UNITED STATES PATENT AND TRADEMARK OFFICE

Office Action Summary

10/736,482

Claims 1-7 are rejected under 35 U.S.C. 103(a) as obvious over Overdiek et al.

FIG. 2A

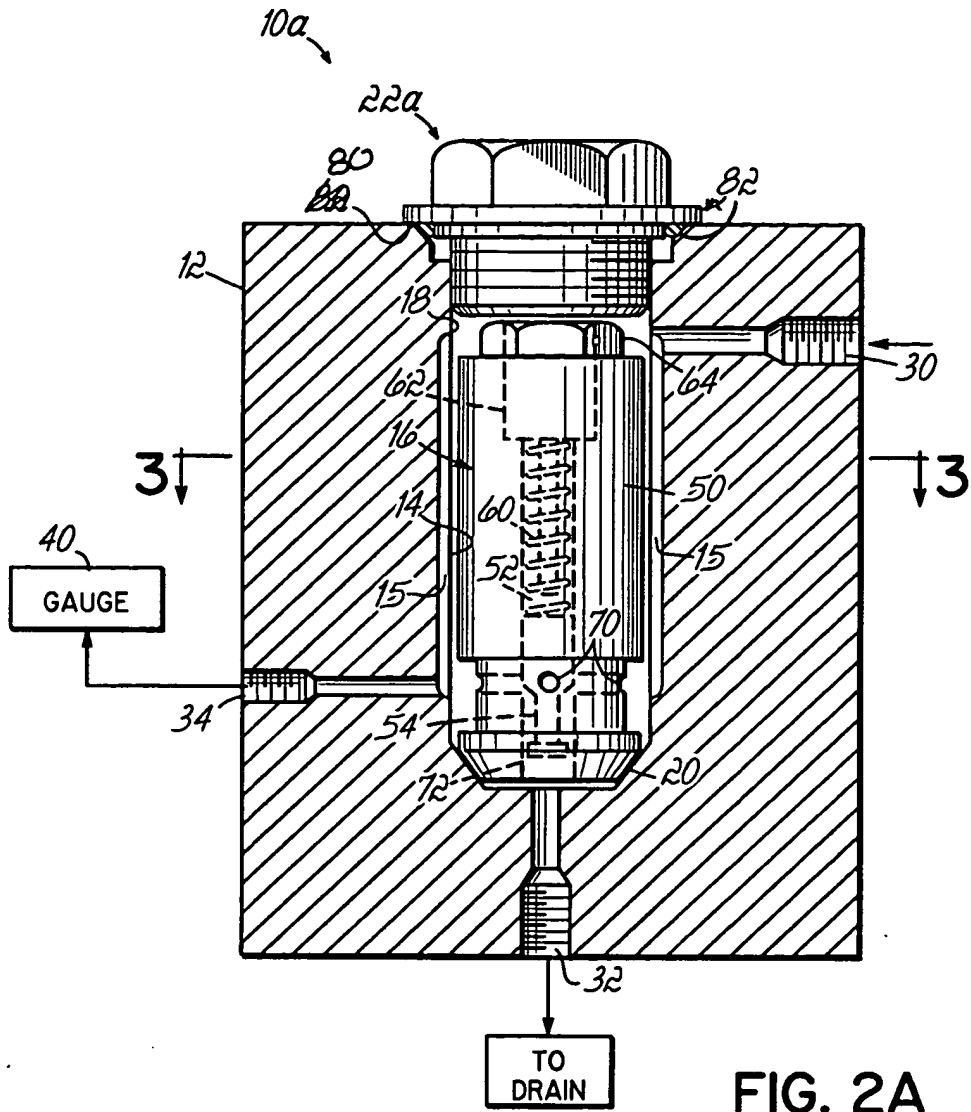
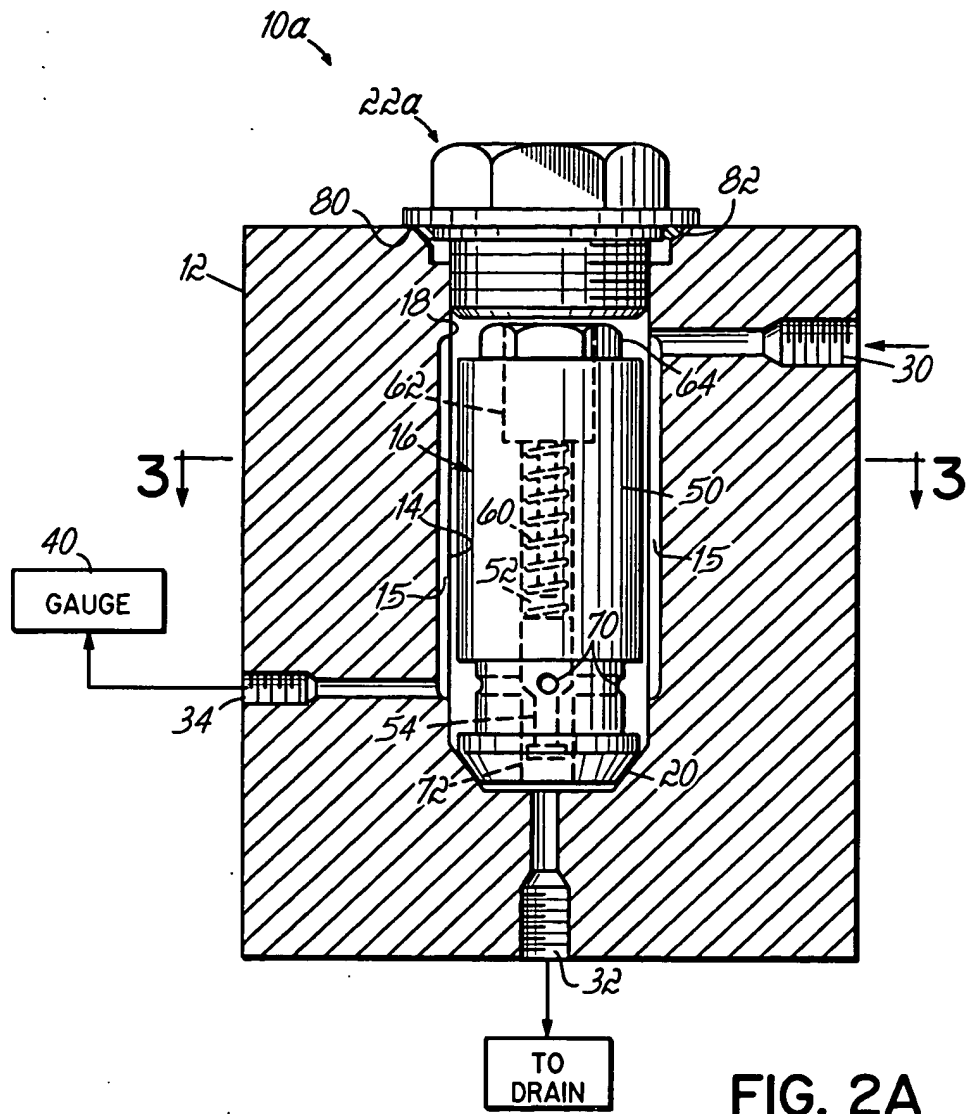
Annotated Sheet Showing Changes

Approved
RR
11/27/05

FIG. 3

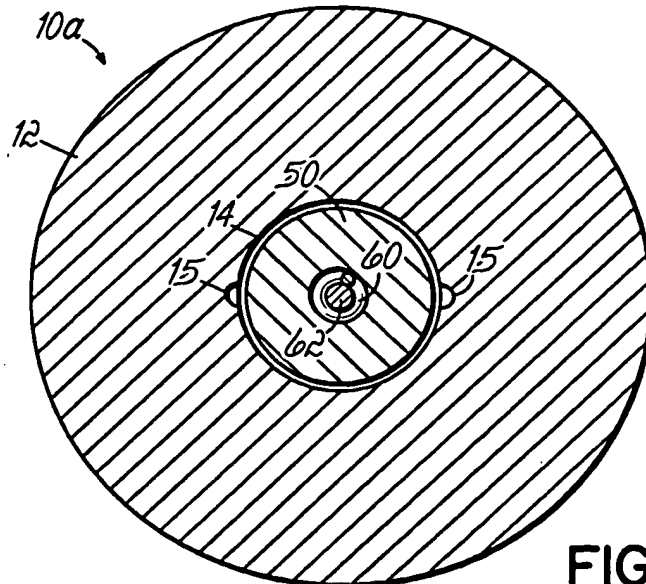
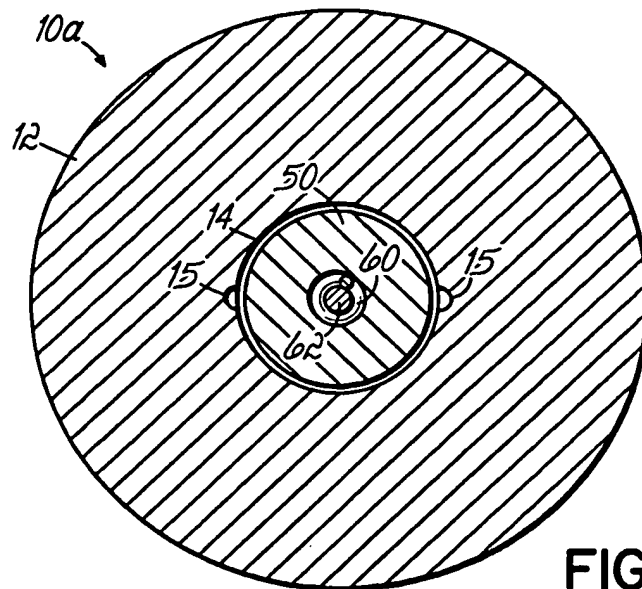
Approved
R2
11/27/05
